DESIGN	q	DART AEROSPACE LTD	
DRAWN	RF	HAWKESBURY, ONTARIO, CANADA	
CHECKED	q	DRAWING NO.	REV. B
MFG. APPR.	E	D058-676-141	SHEET 2 OF 4
APPROVED	q	TITLE	SCALE
DE APPR.	q	CROSSTUBE ASS'Y (OH-58 HIGH FWD)	NTS
DATE	08.11.06	COPYRIGHT © 2000 BY DART AEROSPACE LTD THIS DOCUMENT IS PRIVATE AND CONFIDENTIAL AND IS SUPPLIED ON THE EXPRESS CONDITION THAT IT IS NOT TO BE USED FOR ANY PURPOSE OR COPIED OR COMMUNICATED TO ANY OTHER PERSON WITHOUT WRITTEN PERMISSION FROM DART AEROSPACE LTD.

DRAWING NO. D058-676-141	TITLE CROSSTUBE ASS'Y (OH-58 HI FWD)	REV. B	DART AEROSPACE LTD ENGINEERING ORDER		D.E.O. NO. D058-676-141-B-1	SHEET NO. SHEET 1 OF 1	SCALE NTS
DRAWN <i>q</i>	CHECKED <i>ASS</i>	MFG. APPR. <i>18</i>	APPROVED <i>MP</i>		DE APPR. <i>#</i>		
DATE 11.07.15	DATE 11.07.20	DATE 11.07.21	DATE 11/07/21		DATE 11.07.21

PURPOSE:

REPLACE MAGNOBOND WITH PROSEAL.

D058-676-141
ASSEMBLY DETAIL
(VIEW LOOKING FWD)

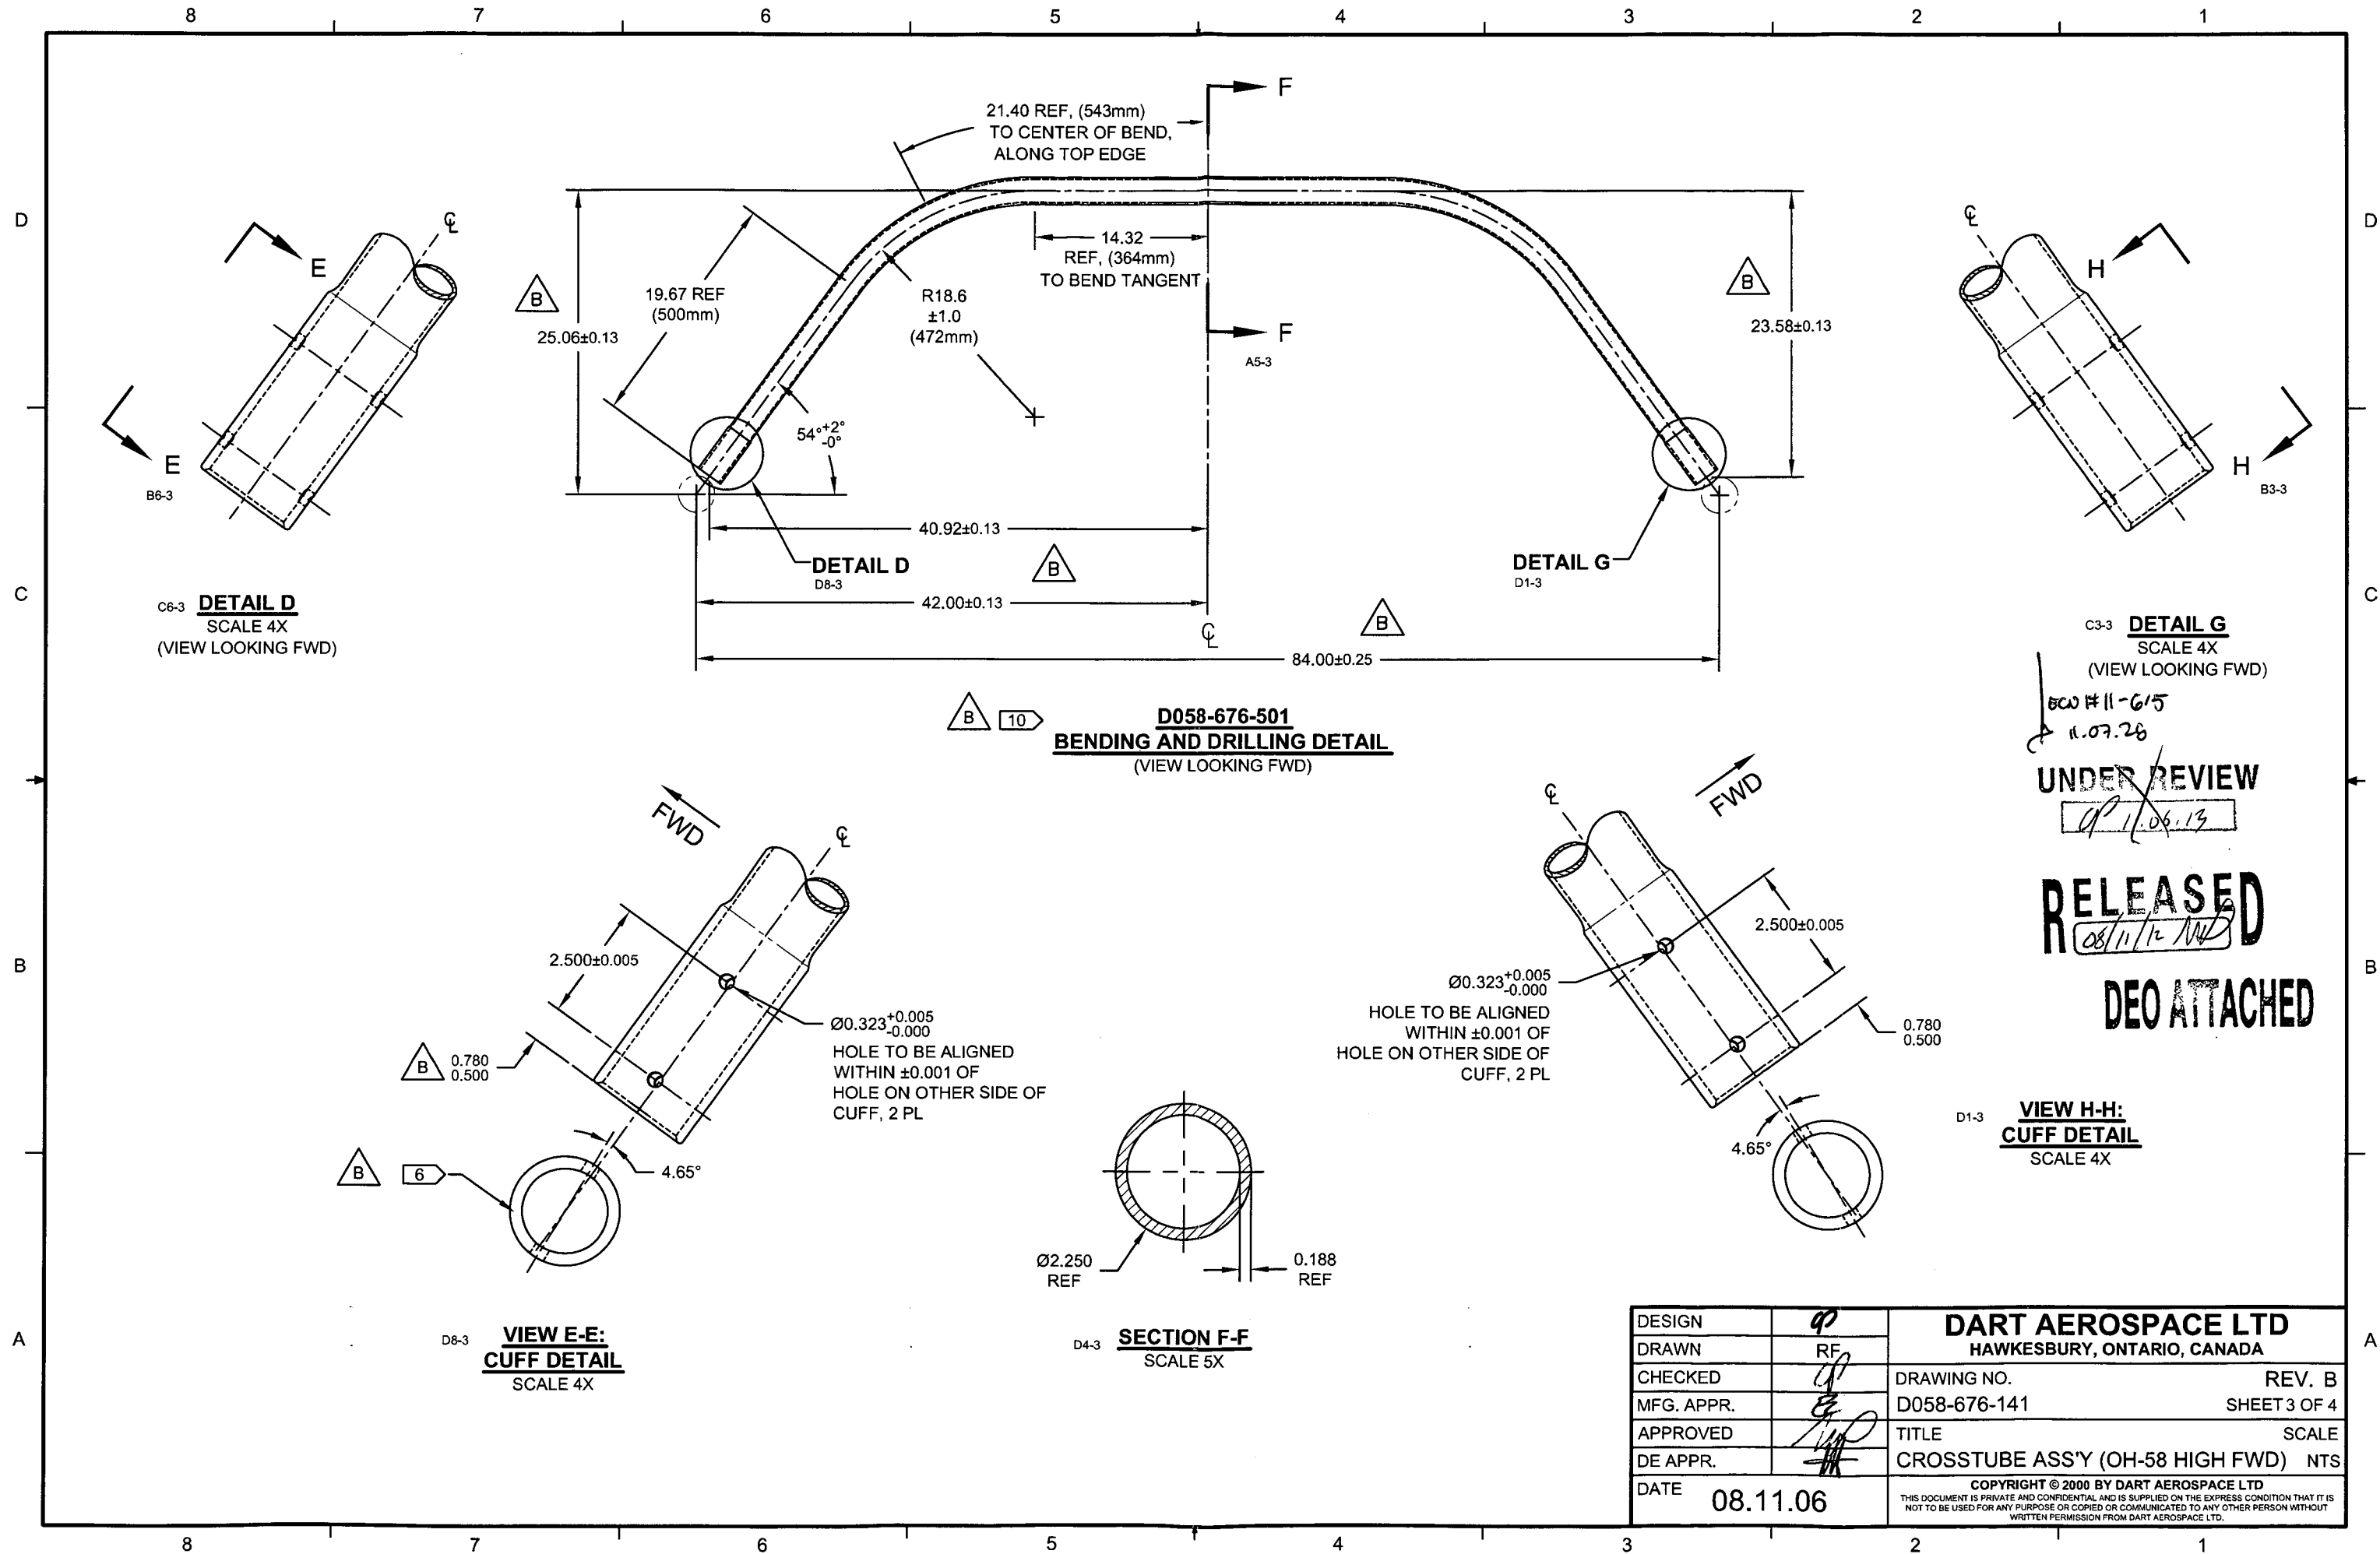
Item	Qty -141	Part Number	Description
6	A/R	PROSEAL 890 B-2	SEALANT, AMS-S-8802 CLASS B-2

6	A/R	MAGNOBOND 6398	ROCKWELL SPECIFICATION RBO-120-023 ADHESIVE (TEXTRON/BELL SPEC. 299-947-100, TYPE II, CLASS 2 ADHESIVE)
---	-----	----------------	---

NOTE 12 & 15, SHEET 1 IS AMENDED AS FOLLOWS:

- 12) INSTALL D2891-1 SUPPORT USING 0.03" TO 0.06" THICK LAYER OF MAGNOBOND 6398 PER QSI 015. LET CURE FOR 12 HOURS AFTER INSTALLATION AND PRIOR TO PACKAGING.
- 15) TORQUE CLAMPS 80 TO 100 IN-LB. ENSURE AT LEAST 1.5 THREADS SHOWING IN SAFETY AND THAT NUT HAS NOT BOTTOMED-OUT AFTER TORQUING.

- 12) TO INSTALL D2891-1 SUPPORT: ABRABE MATING SURFACE OF SUPPORT AND CROSSTUBE WITH 180-GRIT SANDPAPER AND REMOVE RESIDUE WITH MEK (OR EQUIVALENT). APPLY A 0.04" TO 0.07" THICK LAYER OF PROSEAL 890 CLASS B-2 (OR AMS-S-8802 CLASS B-2) SEALANT TO MATING SURFACE OF SUPPORT.
- 15) TORQUE CLAMPS 80 TO 100 IN-LB. ENSURE AT LEAST 1.5 THREADS SHOWING IN SAFETY AND THAT NUT HAS NOT BOTTOMED-OUT AFTER TORQUING. **PRIOR TO PACKAGING, RE-CHECK TORQUE ON CLAMPS AFTER PROSEAL 890 SEALANT HAS CURED FOR 72 HOURS.**
